BUILDING PERMIT

This is to certify that Wilson Samuel E III Va Vet & Family Co  
 has permission to Build new 3 season 8' x 16' sunn  
 AT 259 Spring St City of Portland  
 CE# 056 G032001

**City of Portland, Maine - Building or Use Permit Application**

Proposed Use: Single Family / Build new 3 season 8' x 16' sunroom.	Proposed Project Description: Build new 3 season 8' x 16' sunroom.
---	---

NORTH ELEVATION PROPOSAL

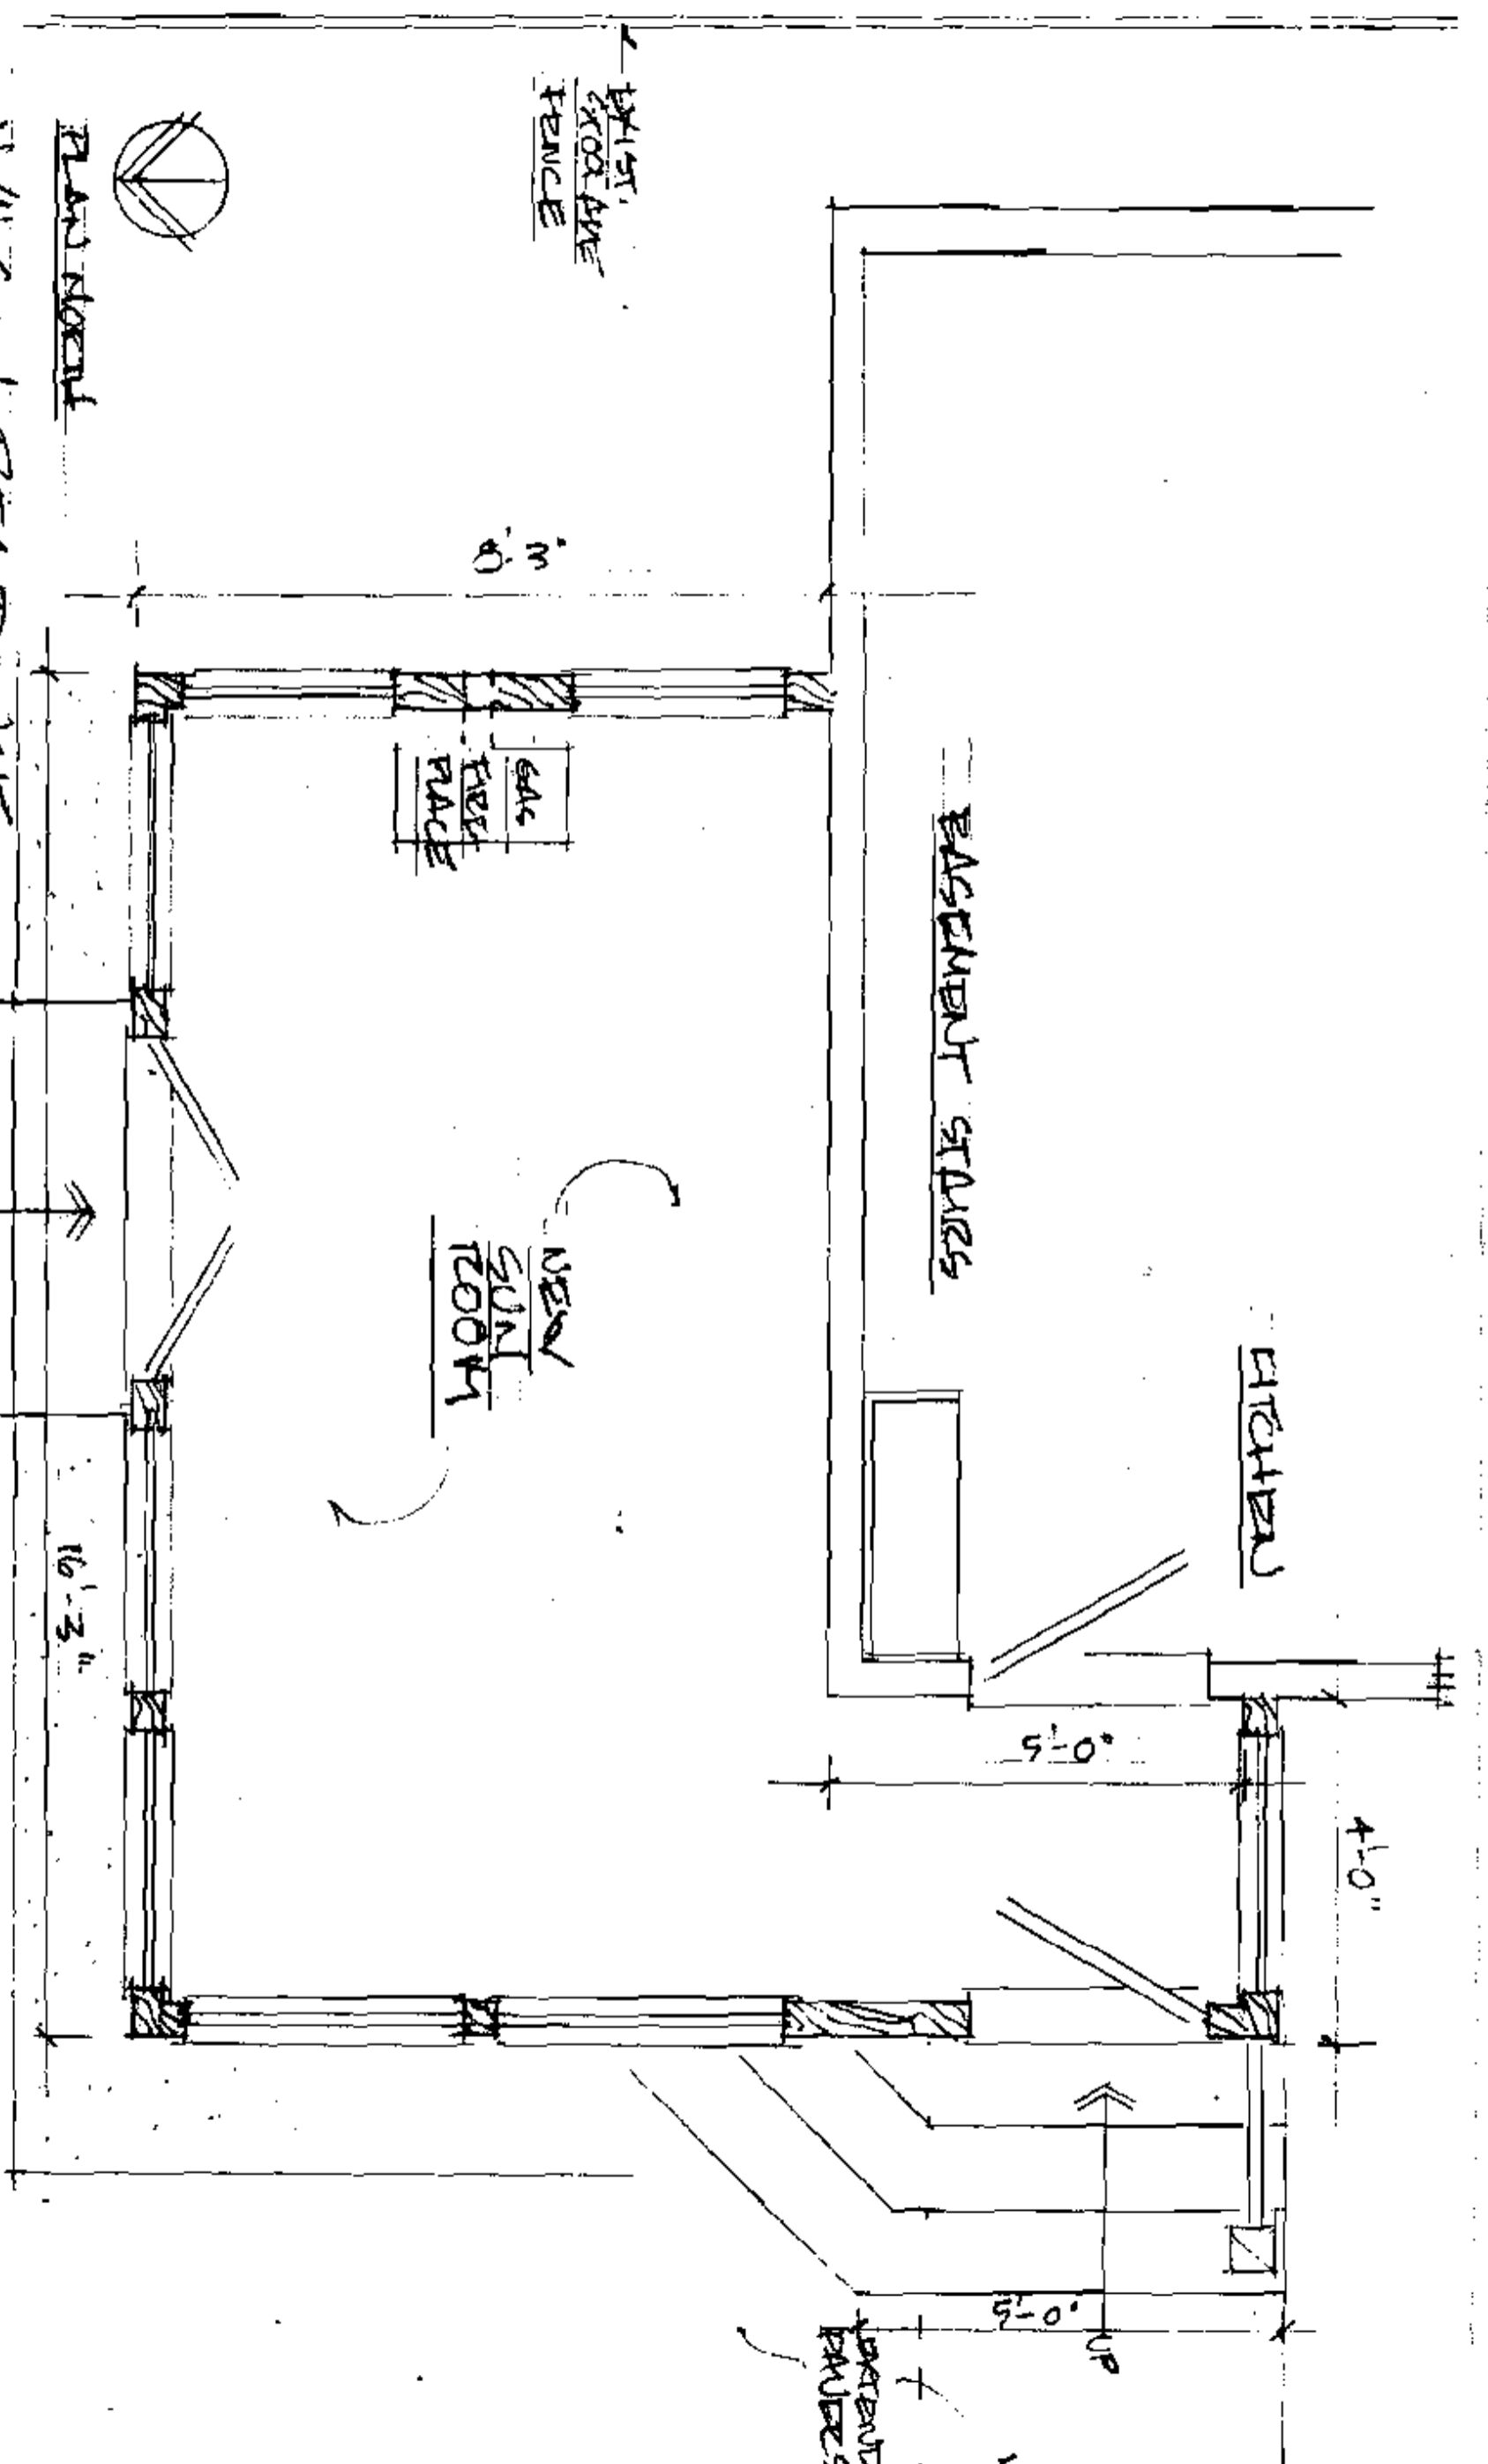
The north side does not require a handrail, but the entry on the west side does as there are actually 4 risers to the floor level, IRC 2003 Sec. R311.5.6. If you continue to read, the height is a minimum of 34" and a maximum of 38" with the grip size as stated in R311.5.6.3(2). Hopefully Deb in historic will agree to these details.

For the 2 large platform steps from the 4' pair of double doors on the north side, the rise is 7" and tread 18". They will be used rarely, and are designed to have planter containers set on either side, without railings.
